1822 Bank Street

URBAN DESIGN BRIEF - R2

MARCH 17, 2025

RESPONSE TO URBAN DESIGN COMMENTS

Proposed Project Phasing

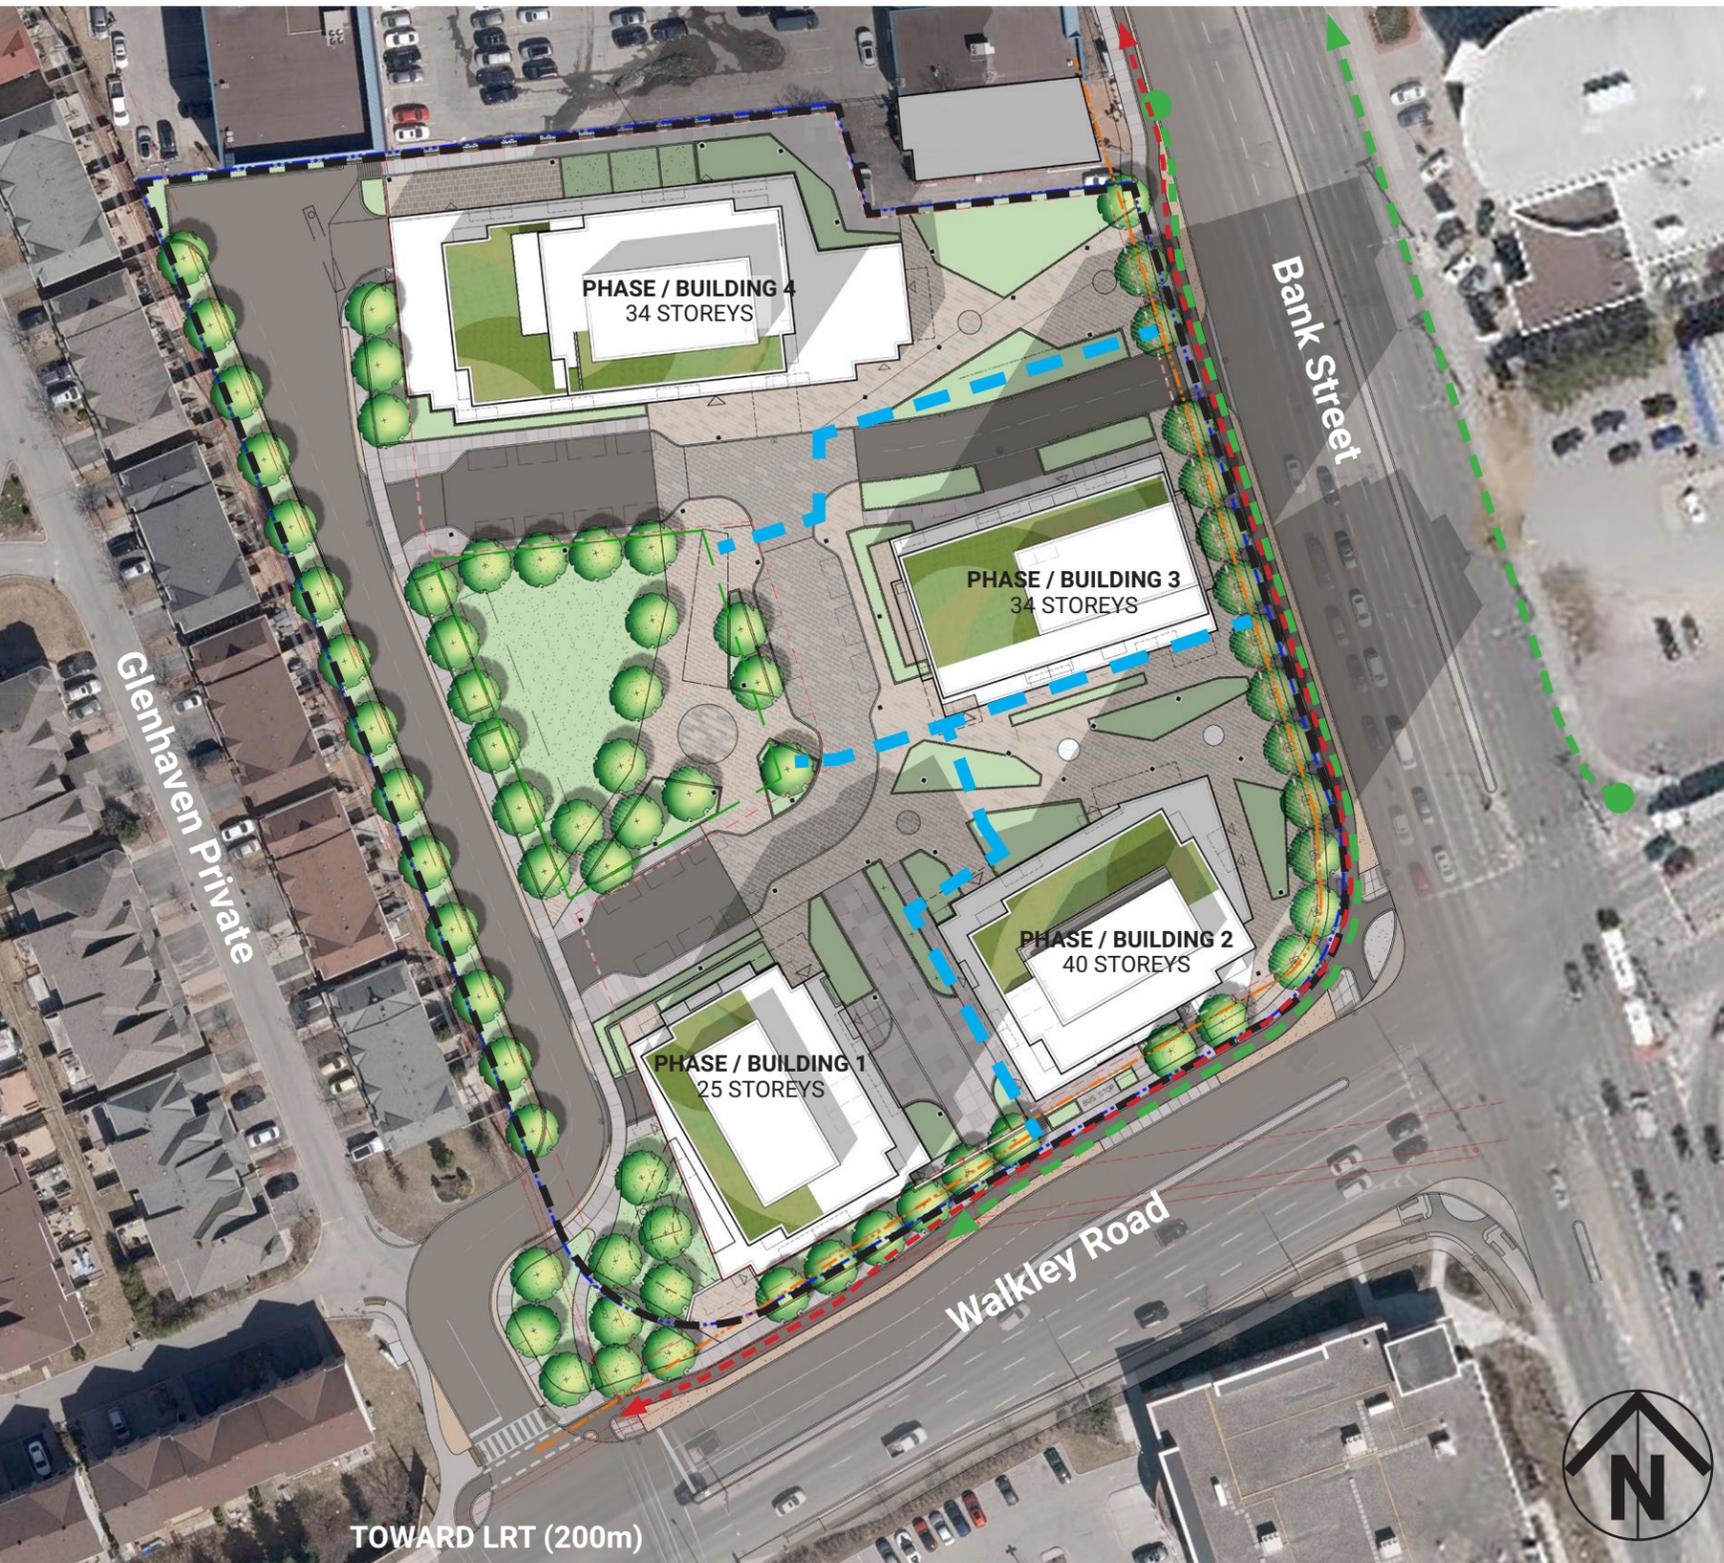
9. Please elaborate on the phasing of the project. There are specific policies in the Secondary Plan with respect to phasing: "New buildings framing Bank Street should be built before any other phases, as per the Secondary Plan". A phasing plan will be a required submission as well. Note: elaborating on the response providing during the meeting where phasing will be focused along Walkley and Bank first with the internal portions (tower 4) being last is acceptable.

Applicant: Concept phasing lines have been added to the concept plan.

FUTURE DEVELOPMENT POTENTIAL

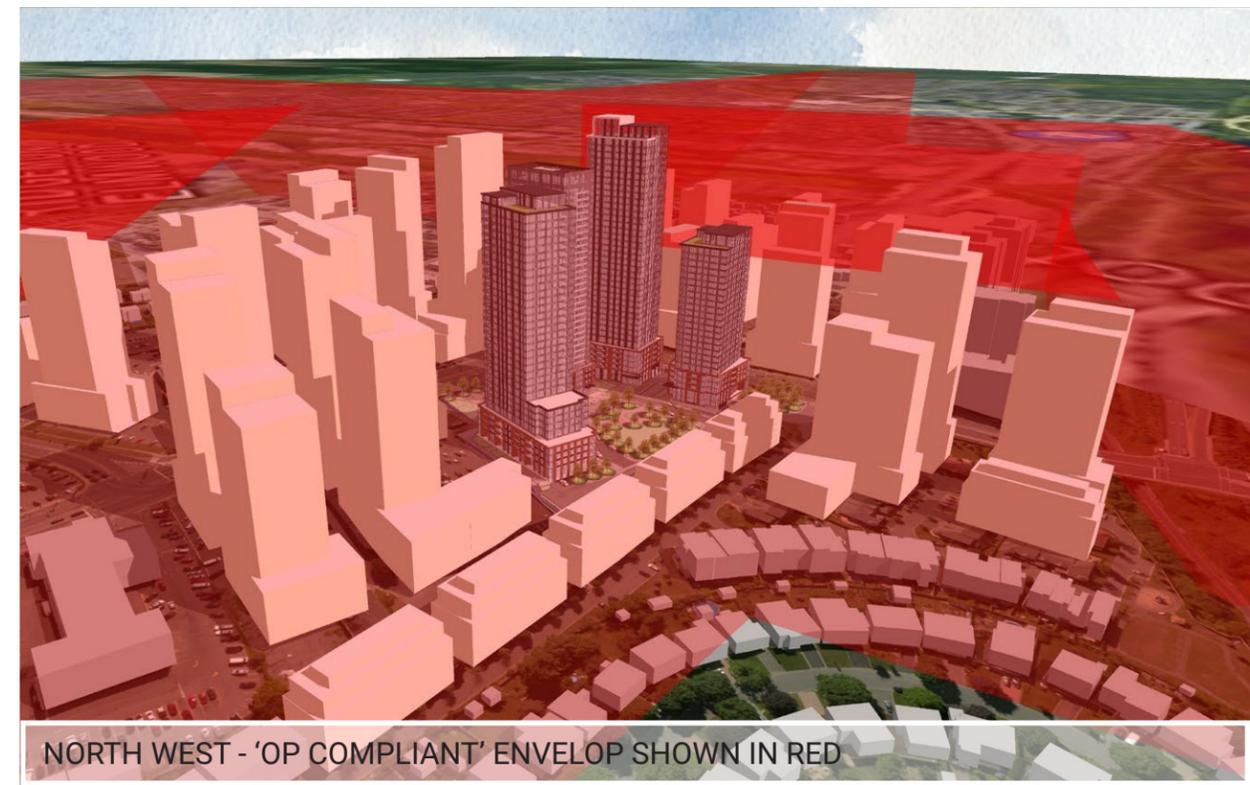
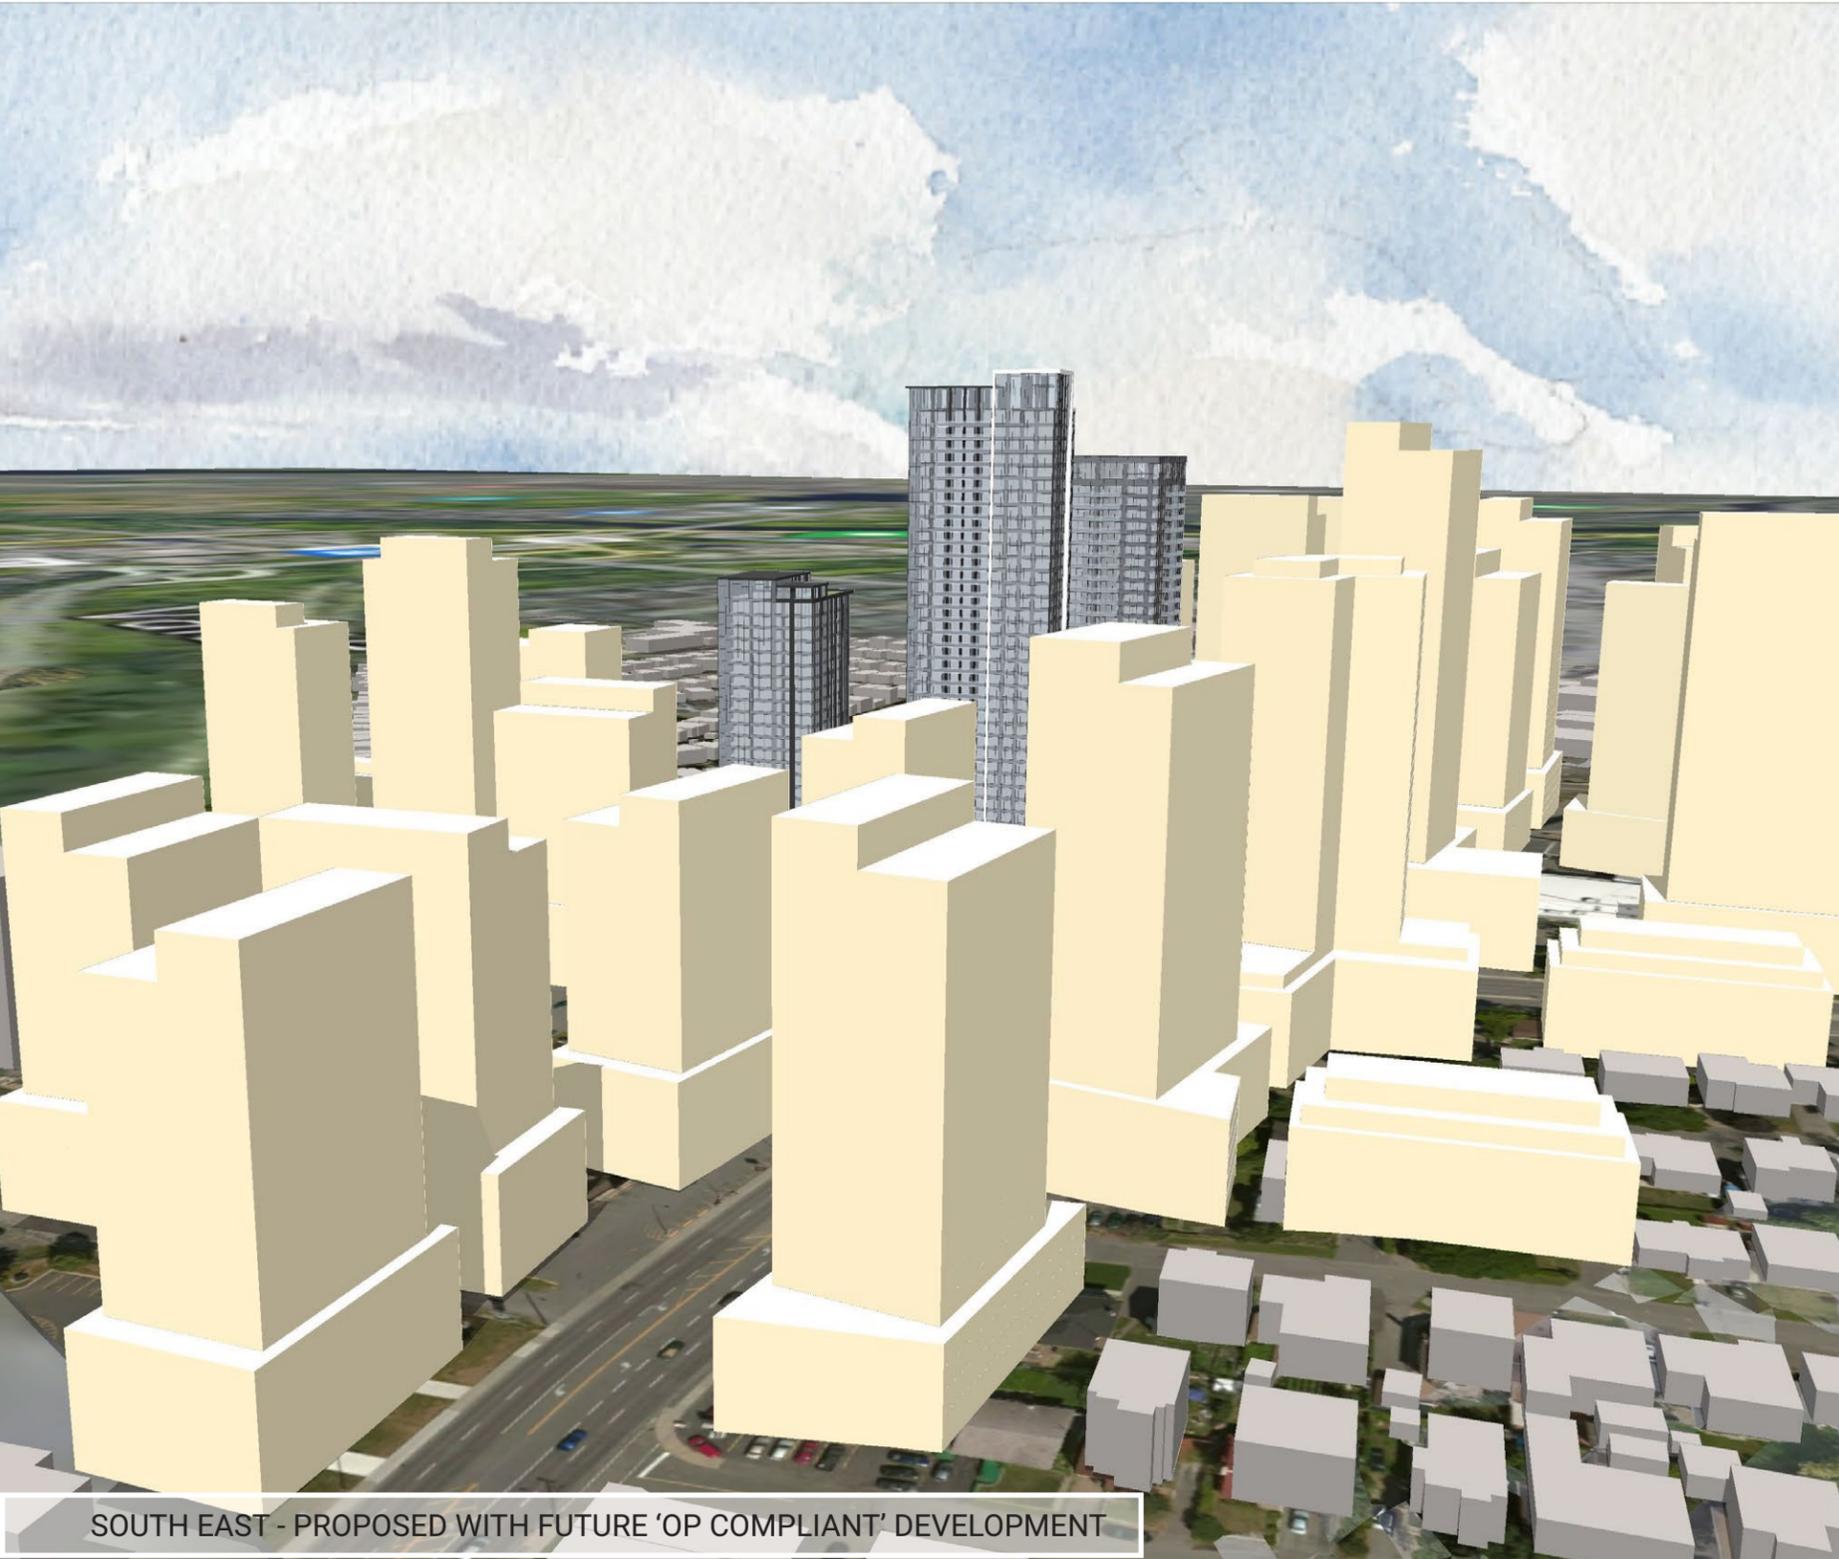
37. It is crucially important to explore and study block plan for the northwest quadrant of Bank and Walkley following directions of the Secondary Plan. A realistic block plan can offer clarity and provide guidance to the design of this site, including street and pathway connections, provision of parks and open spaces, and managing

relationship between neighbouring sites. Such a block plan can serve as a basis for the creation of a plan of subdivision. The attached diagrams illustrate how such a block plan may look like. Please note urban design is not recommending any of these block plan options. The purpose of these diagrams is to simply demonstrate that there may be a range of options and it is necessary to explore block plan options to inform the design of the site.

Applicant: In the UDRP submission deck we have included 'Future Development Potential' massing studies that look at how the blocks to the north may be developed out under the new OP frames and in a pattern that contemplates the extension a street northward to Alta Vista Drive.

Applicant: Images on Pages 21 and 22 (Pages 35-36 on the updated Urban Design Brief) were provided at the request of City of Ottawa Planning staff. They illustrate the proposal in the concept of future development potential as recognized by the Official Plan at a point sometime in the future.
